Regarding the Sierra 60m band module in Sprat 172

Stefan, DL9TX has checked the presented 60m band module with his NWT 500 network analyzer.

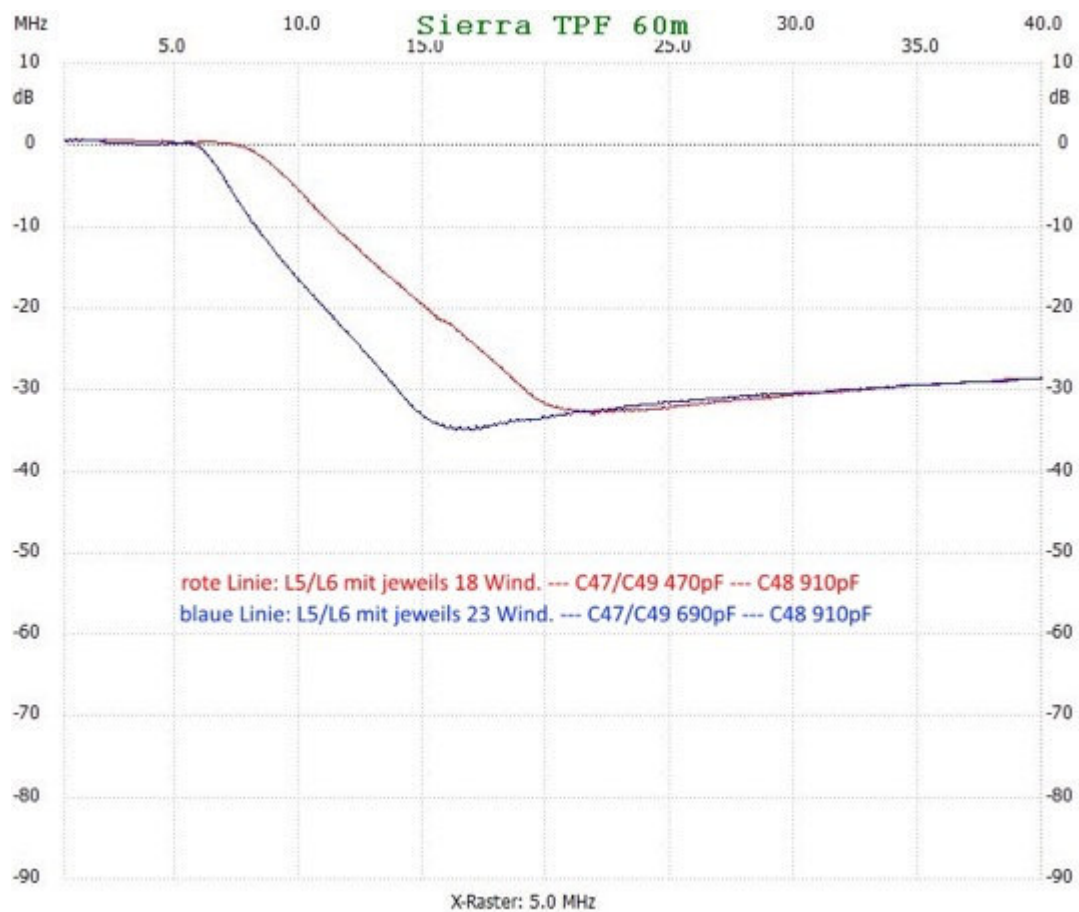
L5 T37-2 ~~1,8uH 18 turns 0.4mm wire~~ change to 2,2uH with 23 turns using 0.4mm wire

L6 T37-2 ~~1,8uH 18 turns 0.4mm wire~~ change to 2,2uH with 23 turns using 0.4mm wire

~~C47 465pF~~ change to:

~~C49 465pF~~ change to:

C47 470pF plus 220pF = 690pF

C49 470pF plus 220pF = 690pF
